From: McConnell, DAVE P <dave.p.mcconnell@lmco.com>
Sent: Thursday, March 16, 2017 1:32 PM
To: Gary Deveau
Cc: Grant Robinson
Subject: FW: Case Resolved: C0055308 - David McConnell - Air Conditioner Compessor CMM-Request For Clarification

Case Number: C0055308
Customer: Thai Aviation Services Limited
Aircraft S/N: 761064
Aircraft Model: S-76D
Aircraft TT: 275
Sub-System: Other
Part Number: 76-0551-1
Entering FSR: David McConnell
Submitted On: 3/10/2017 3:29 AM
Severity: Urgent

Case Subject: Air Conditioner Comperssor CMM-Request For Clarification

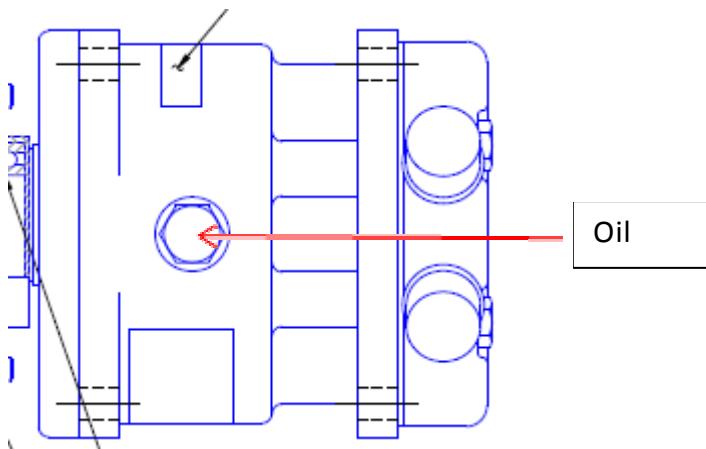
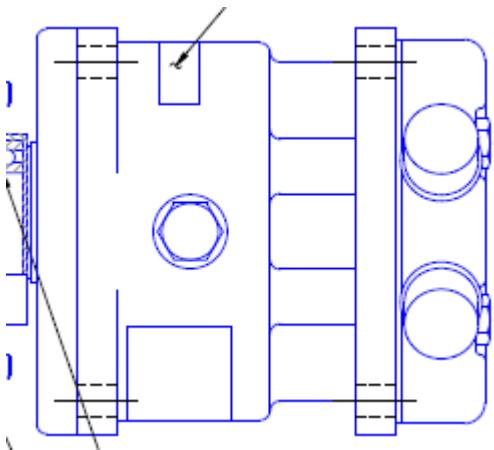
The body of the customer letter references "see below", but there is nothing below. Whatever is was can you email or DocPak to me?

- A3) The oil plug is located at the top of the compressor (see below) and should
A4) You may have to rotate the pulley and shaft a little to move the wobble pl
insert the dipstick at a slight angle.

Below is a bit of artwork for the air conditioner compressor that was inadvertently left off yesterday's customer letter.

Dave,
I do apologize for that. Here you go.
